**NOTICE OF PUBLIC MEETING  
BUILDING AND ZONING COMMITTEE  
LOCATION: TOWN HALL, 50 COLONY ROAD  
DATE AND TIME: WEDNESDAY, MARCH 20, 2024 AT 5:00 PM**

6. Continued Items:
  - A. #20 Ocean Drive: new two-story residence with outdoor pool. Total under air: 6,834 sf. Total square footage: 9,768 sf. Lot occupancy calculation: 47.97% (50% allowed). Maximum building height: 25' (25' allowed).

- B. #34 Ocean Drive: new two-story residence with outdoor pool. Total under air: 3,795 sf. Total square footage: 4,637 sf. Lot occupancy calculation: 49.29% (50% allowed). Maximum building height: 24'-11¼" (25' allowed).

Jupiter Inlet Colony Plan Review

**A1**  
NOT FOR CONSTRUCTION  
PRINT DATE: 2-27-24

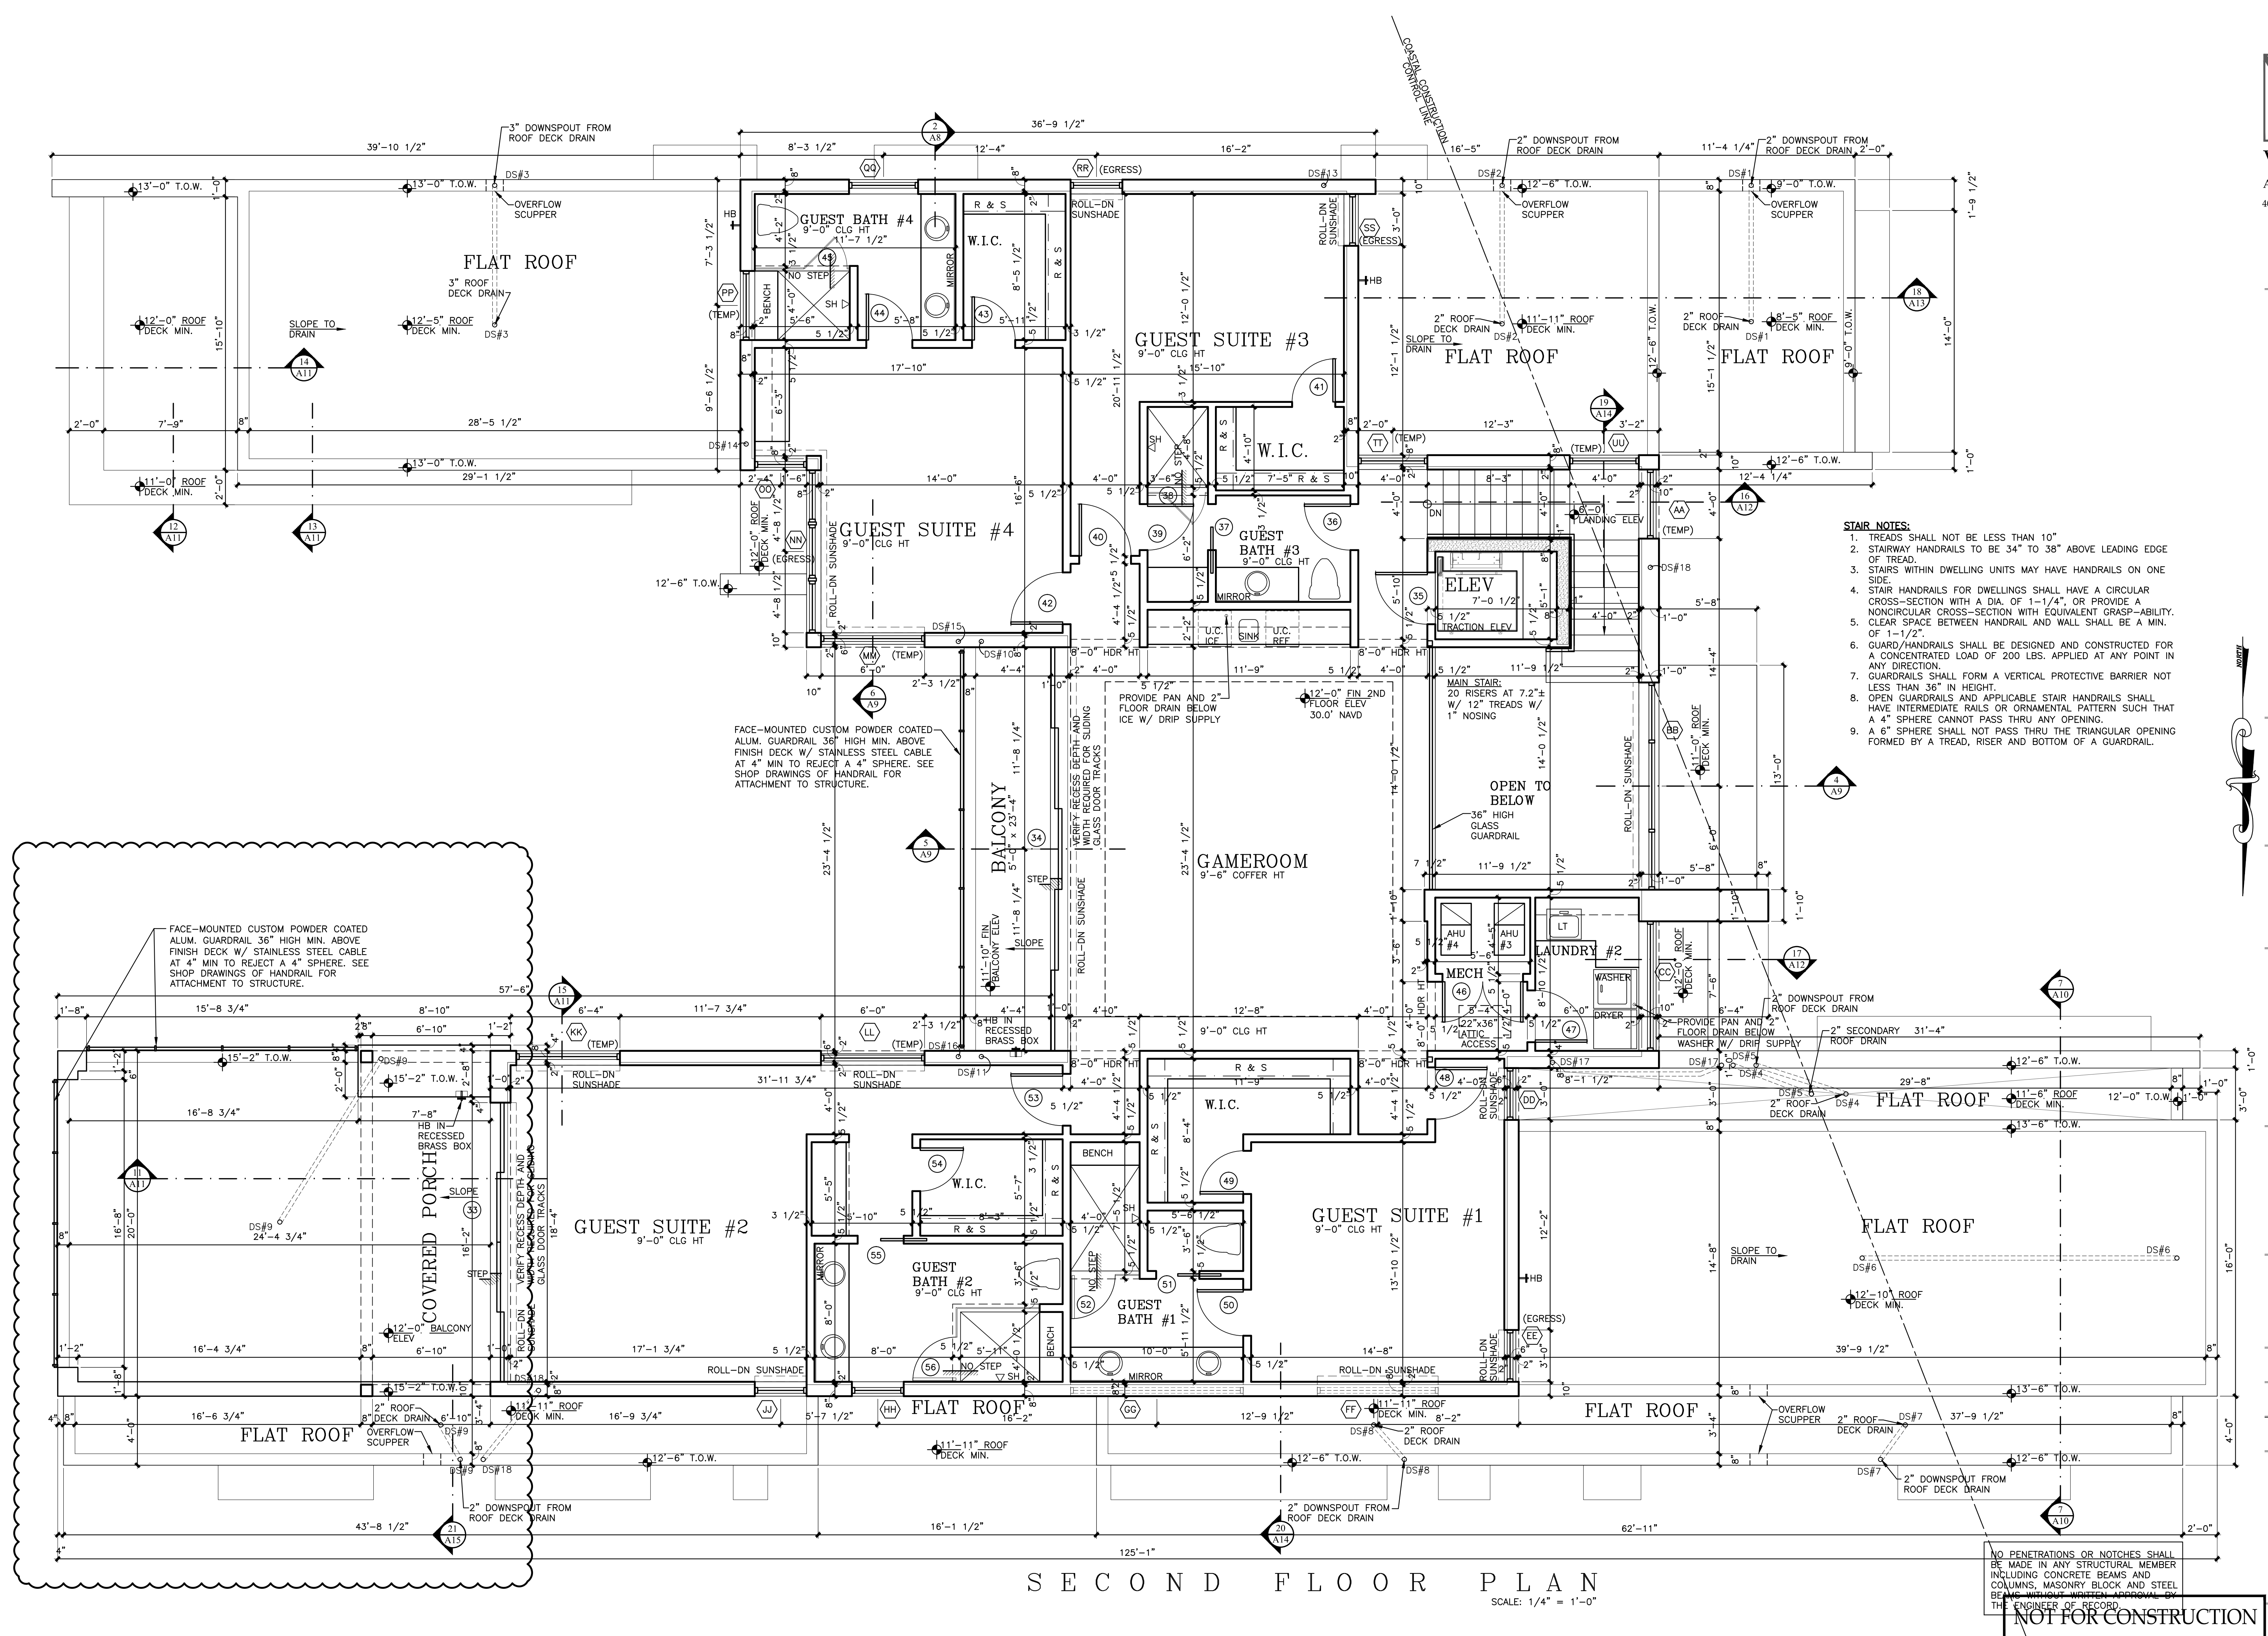
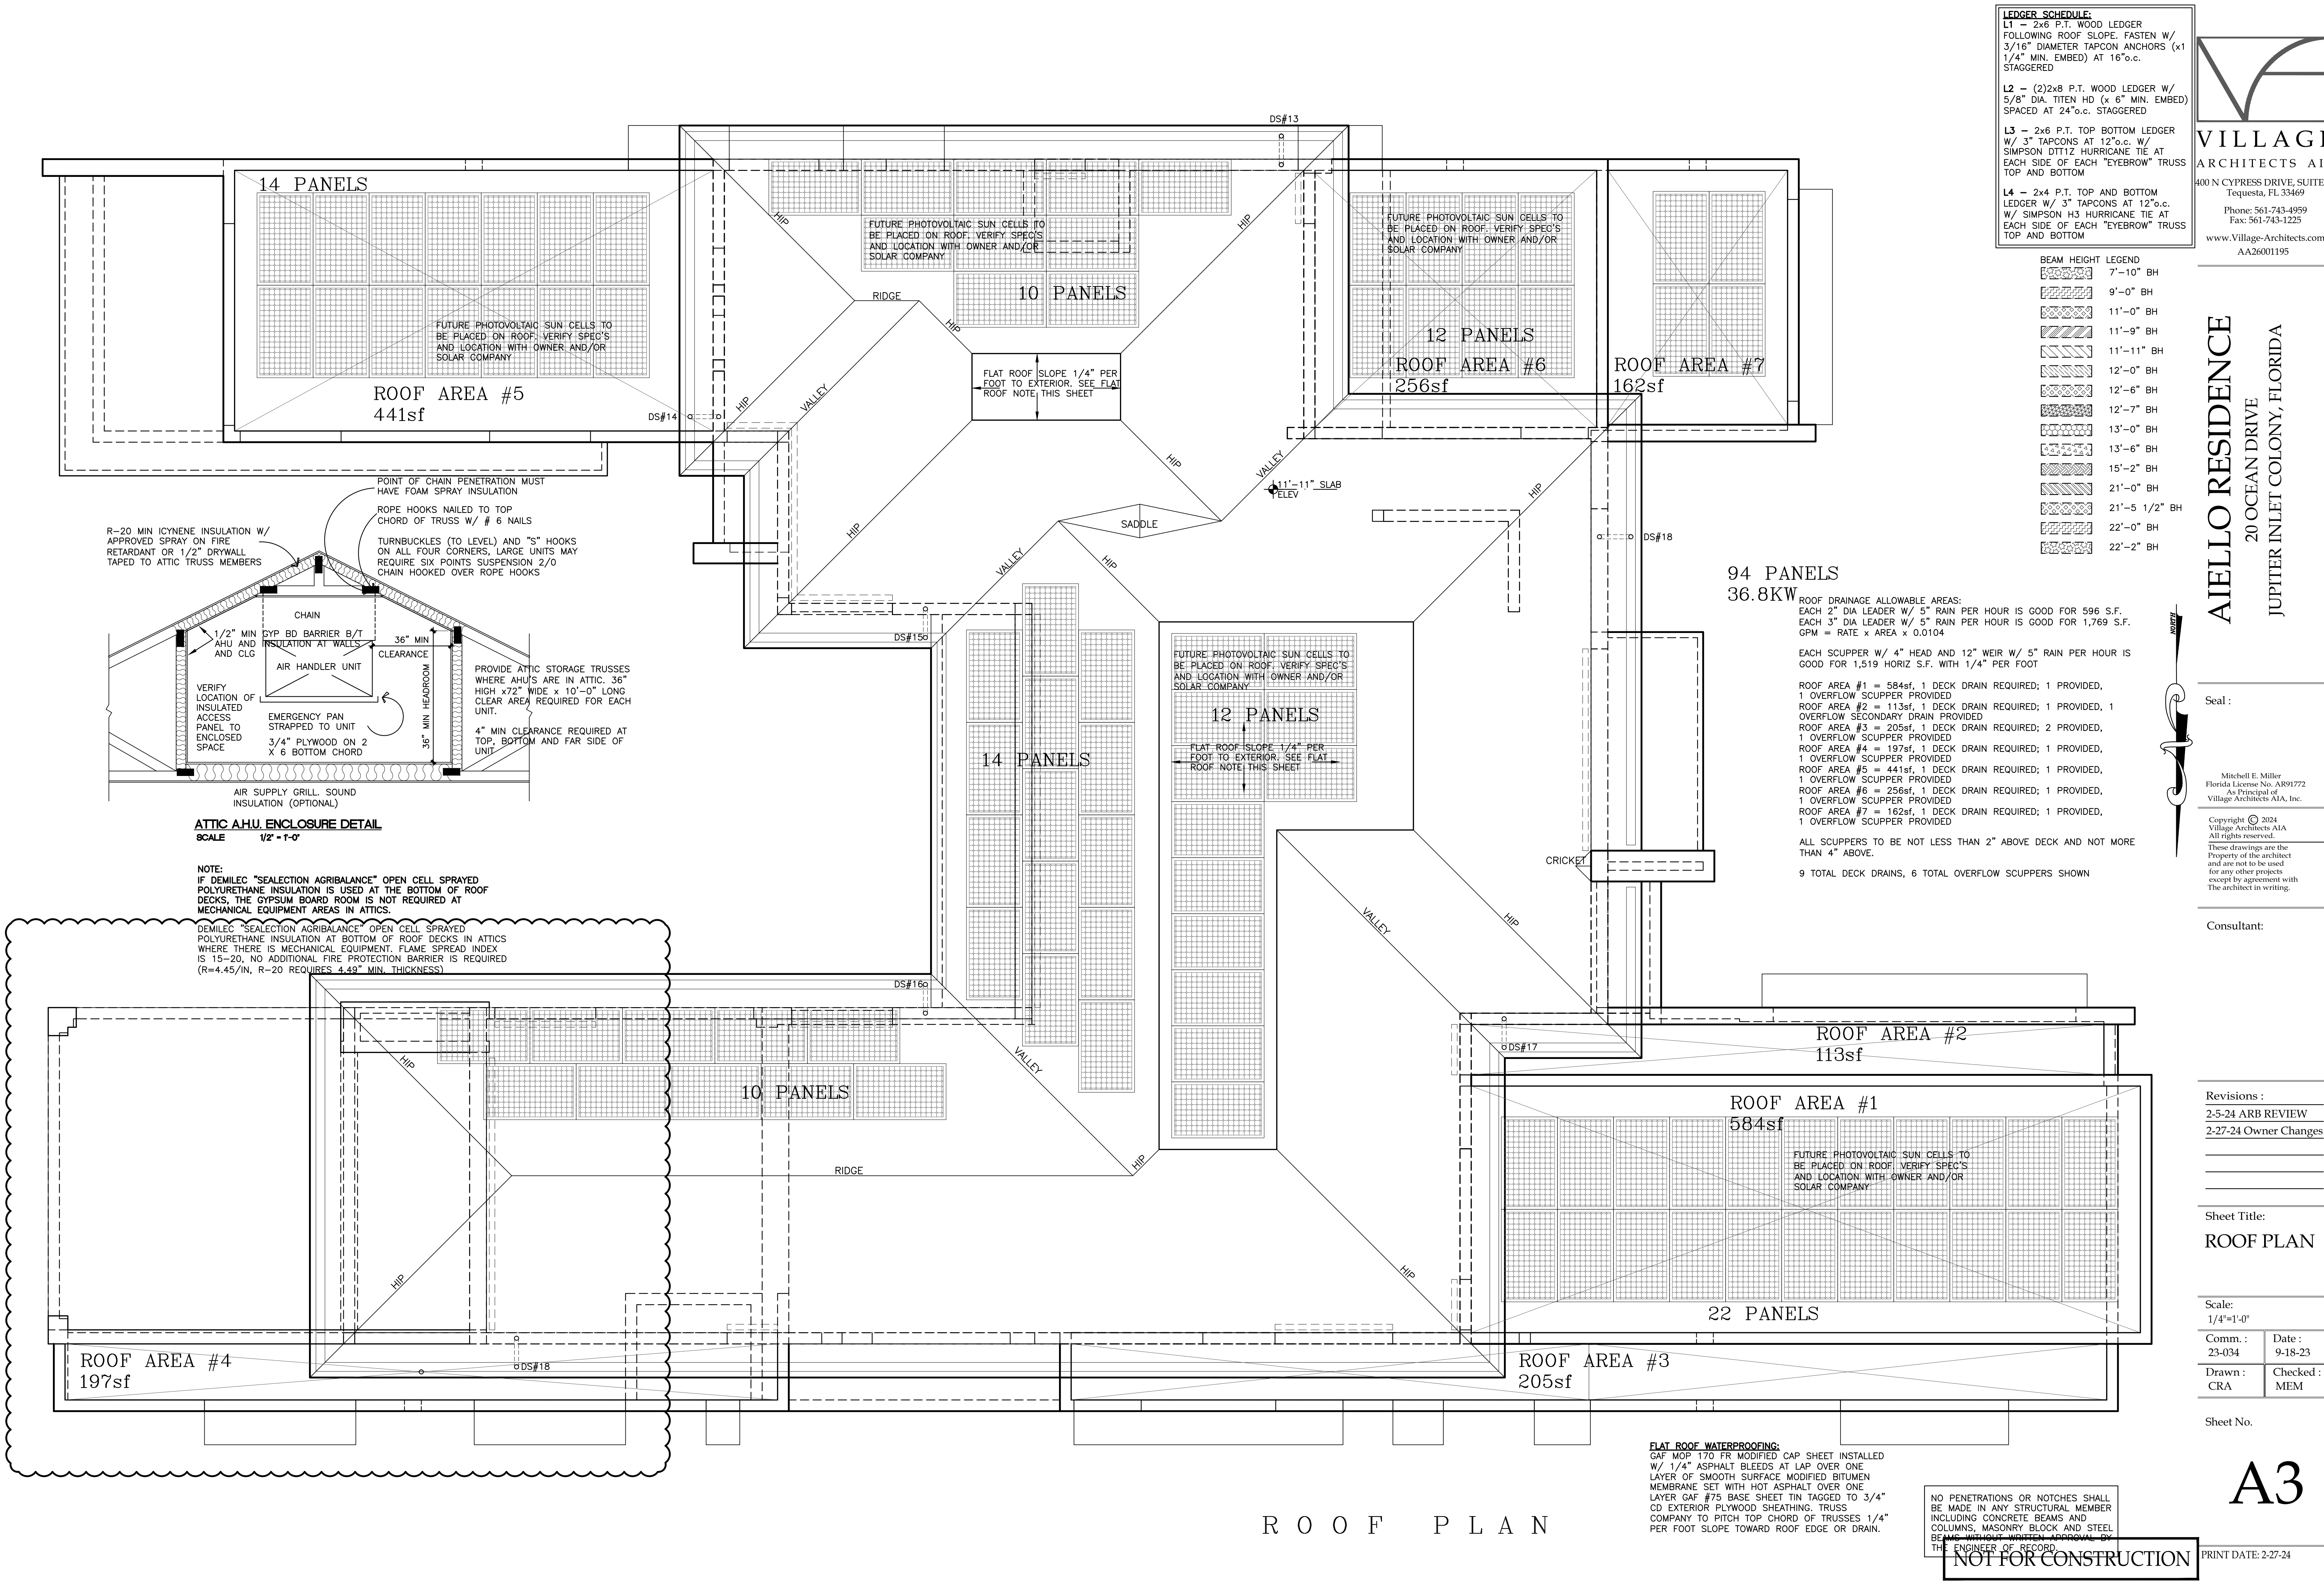
- Extended the Summer Kitchen eastward approx. 8'
- Removed the stairs down to the now removed basement
- Added storage mezzanines in both garages

18 GARAGE #2 DETAIL  
A13 SCALE: 3/4"= 1'-0"

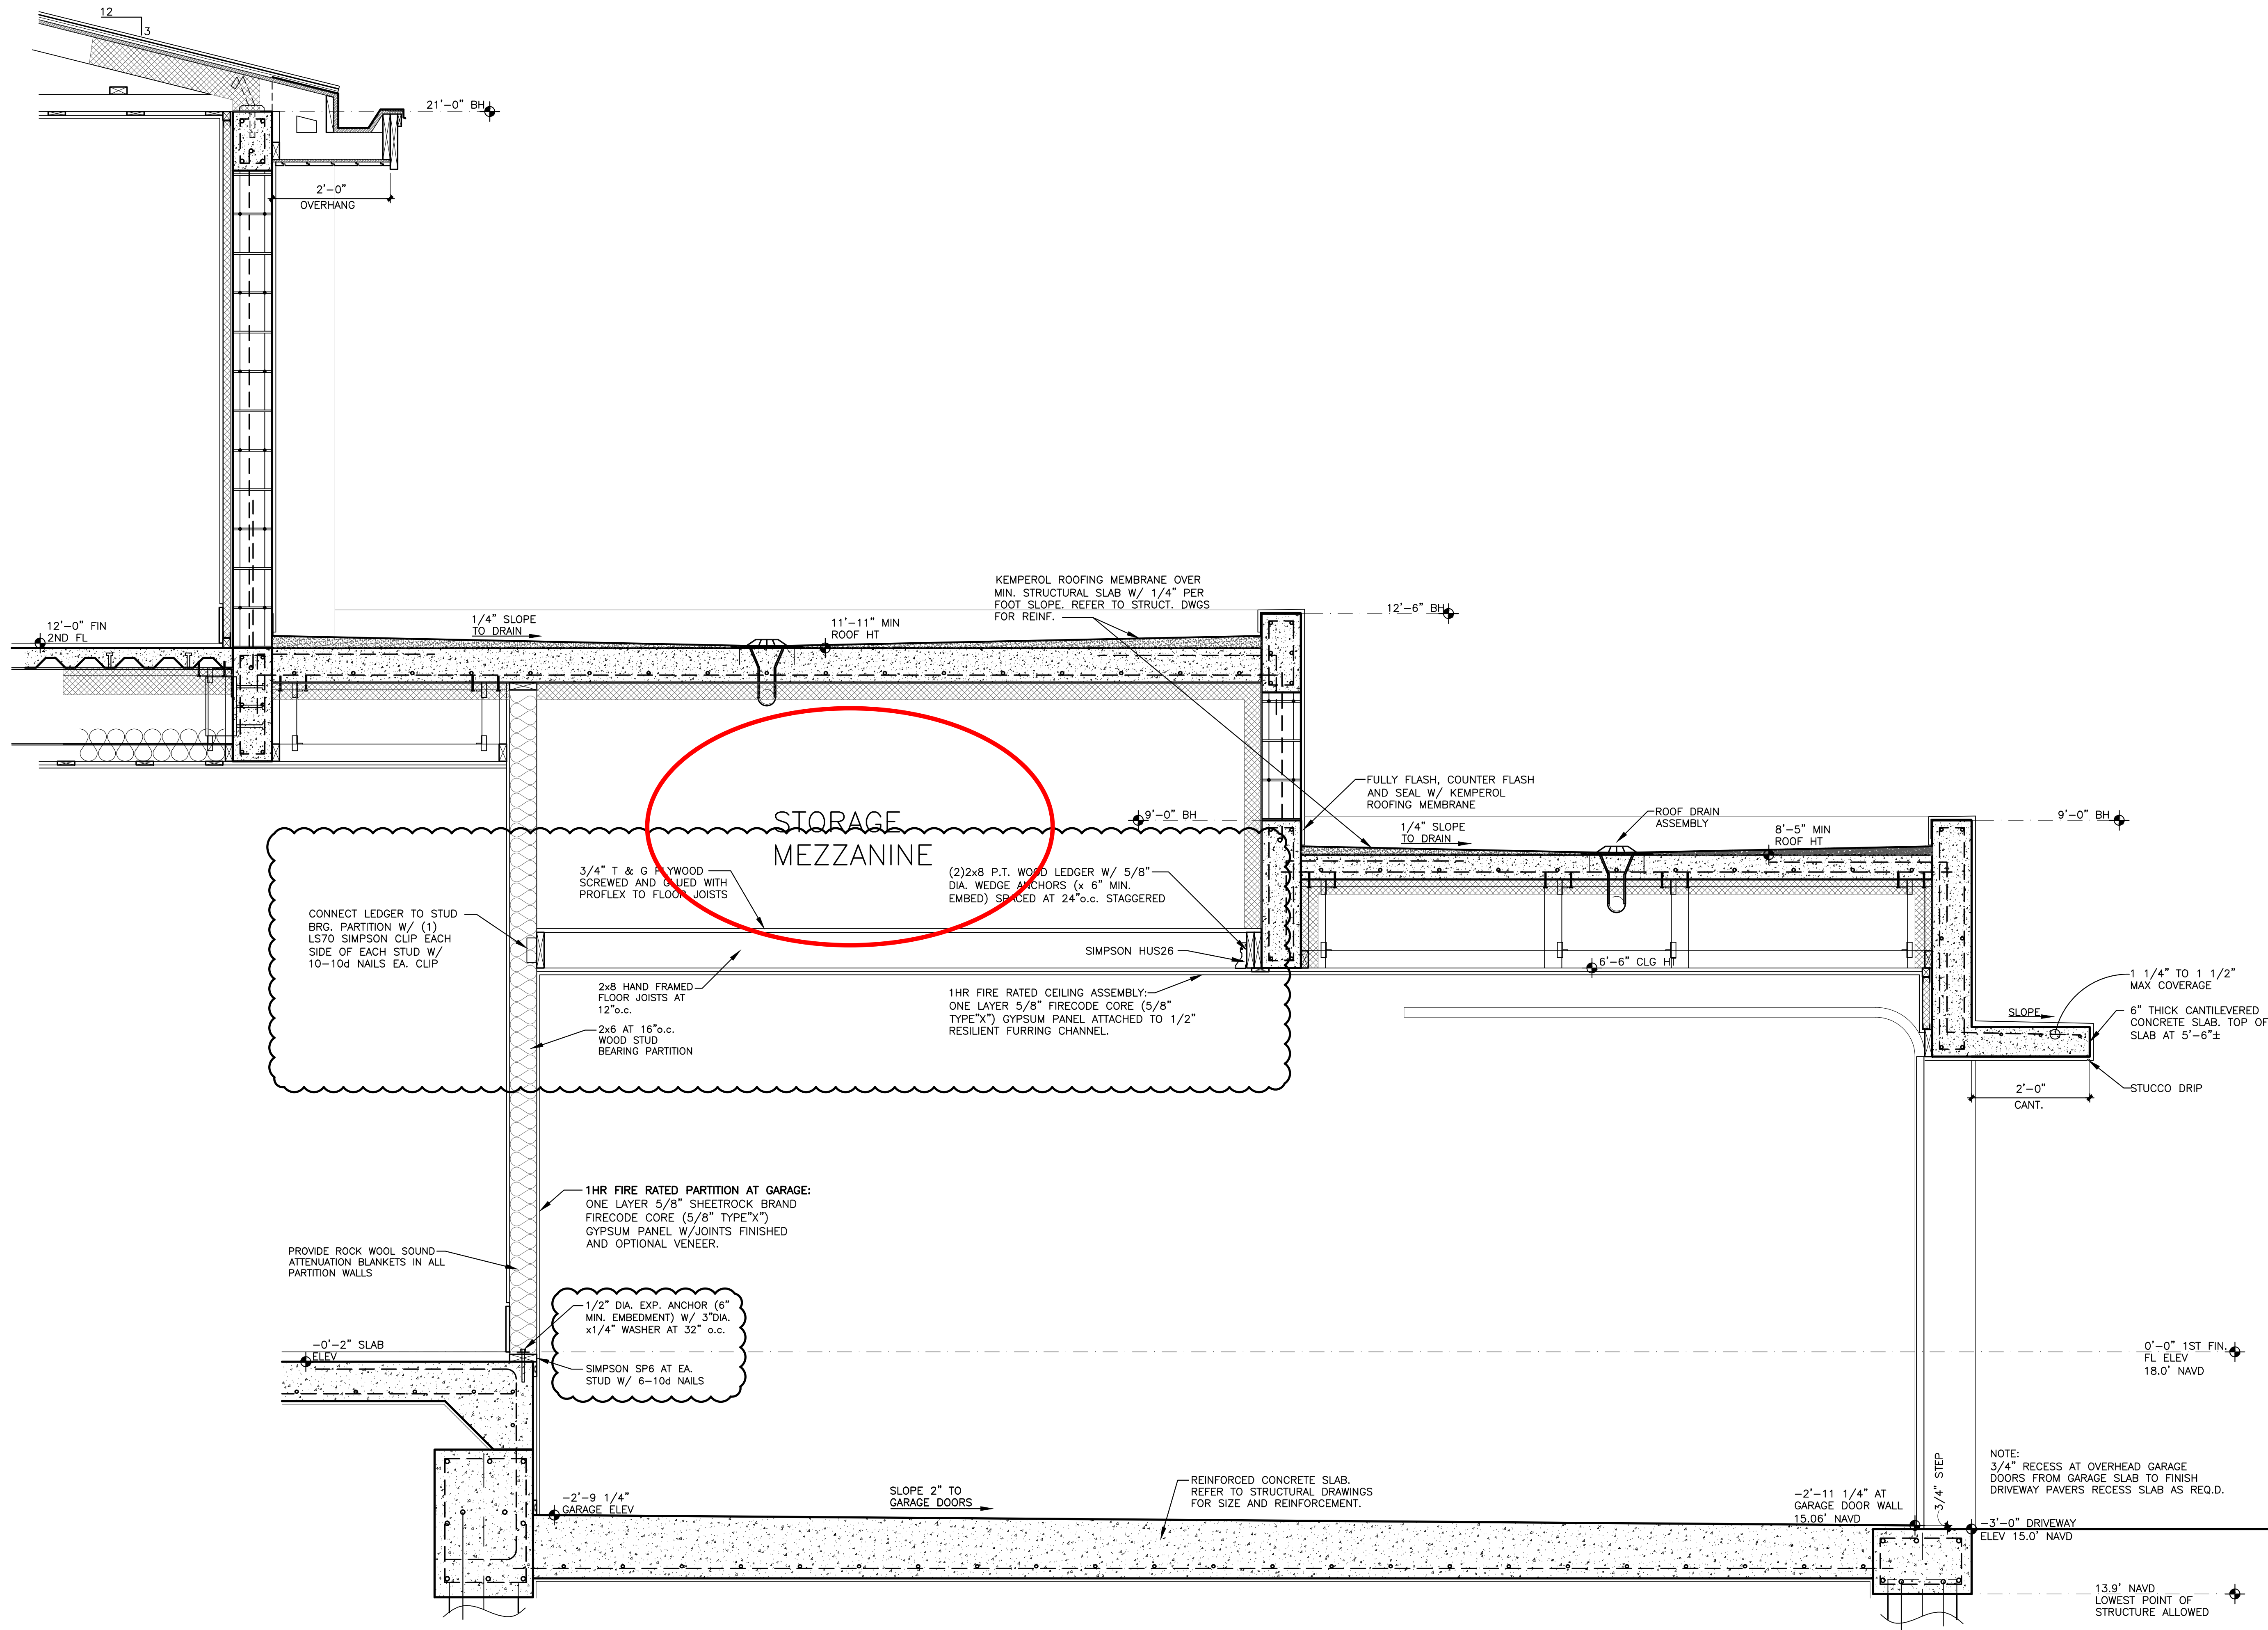
- A new storage mezzanine has been added at garage #2
